APPLICATION NO.	FILING DATE	FIRST NAMED INVENTOR	ATTORNEY DOCKET NO.	CONFIRMATION NO.
10/709,989	06/11/2004	Yui-Shin Fran	12960-US-PA	3988
31561	7590	04/05/2006	EXAMINER	
JIANQ CHYUN INTELLECTUAL PROPERTY OFFICE 7 FLOOR-1, NO. 100 ROOSEVELT ROAD, SECTION 2 TAIPEI, 100 TAIWAN			WON, BUMSUK	
			ART UNIT	PAPER NUMBER
			2879	
DATE MAILED: 04/05/2006

Office Action Summary	Application No.	Applicant(s)	
	10/709,989	FRAN ET AL.	
	Examiner	Art Unit	
	Bumsuk Won	2879

DETAILED ACTION

Section view of figure 8A (Nishiyama)

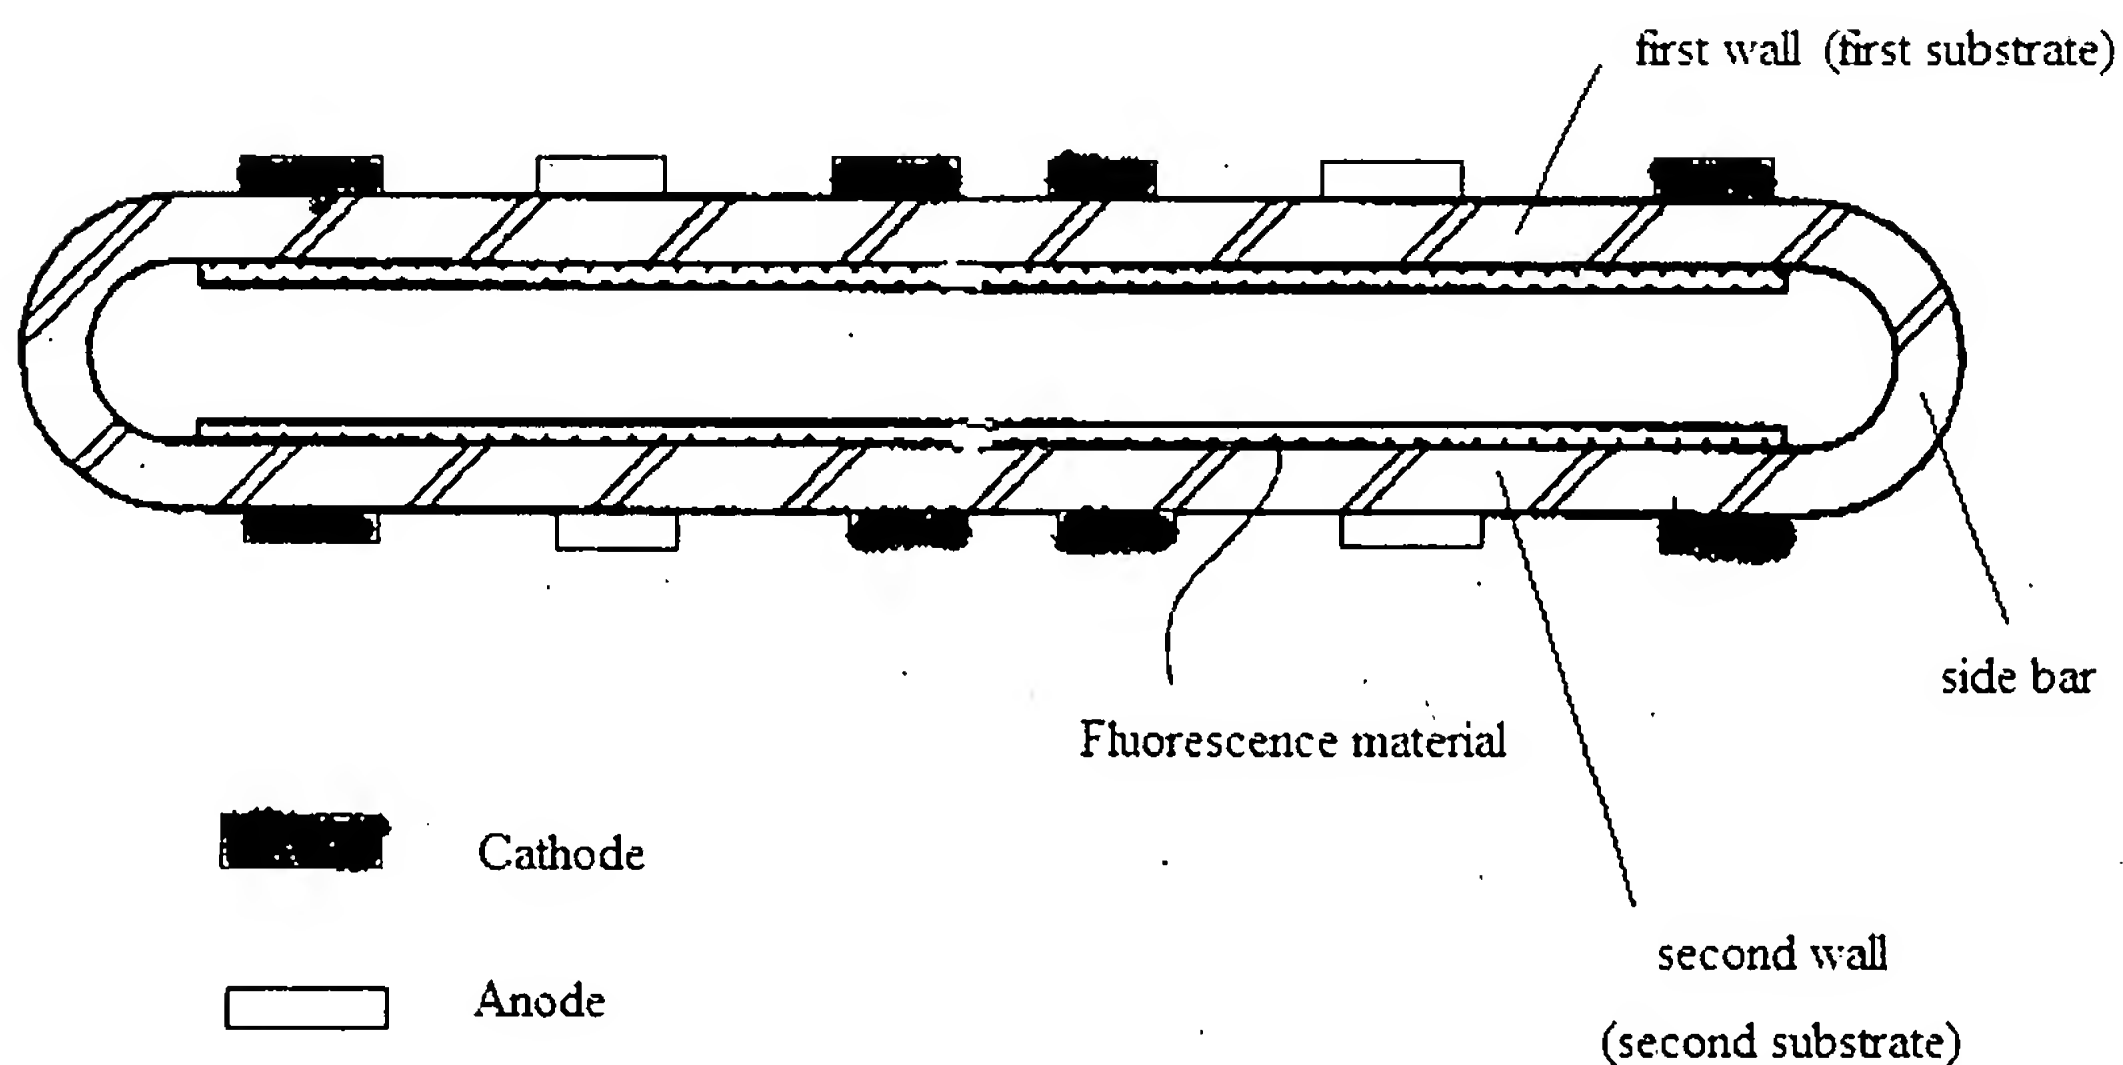
Regarding claim 1, Nishiyama discloses a cold cathode fluorescent lamp (figure 8A), comprising: a cavity (35), comprising a first inner wall (top portion) and a second inner wall (bottom portion) disposed opposite to the first inner wall; a fluorescence material (35q) disposed over the first and the second inner wall; a discharge gas (column 6, lines 11-14) disposed inside the cavity; a first electrode pairs (35c and 35d, top part) disposed over an outer wall of the cavity, wherein each of the first electrode pairs comprises a first anode (top part of 35c) and a first cathode (top part of 35d); and a second electrode pairs (35c and 35d, bottom part) disposed over an outer wall of the cavity, wherein each of the second electrode pairs comprises a second anode (bottom part of 35c) and a second cathode (bottom part of 35d) (see figure *Section view of figure 8A (Nishiyama)* for more detail).

Regarding claim 2, Nishiyama discloses the cavity (35) comprises: a first substrate (top portion); a second substrate (bottom portion) disposed over the first substrate; and a side bar (both right and left end portion) disposed between the first substrate and the second substrate, and the side bar is connected to an edge of the first substrate and an edge of the second substrate (see figure *Section view of figure 8A (Nishiyama)* for more detail).

Regarding claim 3, Nishiyama discloses the first electrode pairs (figures 6A and 8A, 35c, 35d, top part) are disposed over the first substrate (top portion of 35), and the second electrode pairs (figures 6A and 8A, 35c, 35d, bottom part) are

disposed over the second substrate (bottom portion of 35) (see figure *Section view of figure 8A (Nishiyama)* for more detail).

Regarding claims 6 and 7, Nishiyama discloses anodes (figure 8A, 35c) and cathodes (35d) being arranged in a sequence in an order of anode, cathode, cathode, anode (middle 4 electrodes meets the claimed sequence) (see figure *Section view of figure 8A (Nishiyama)* for more detail).
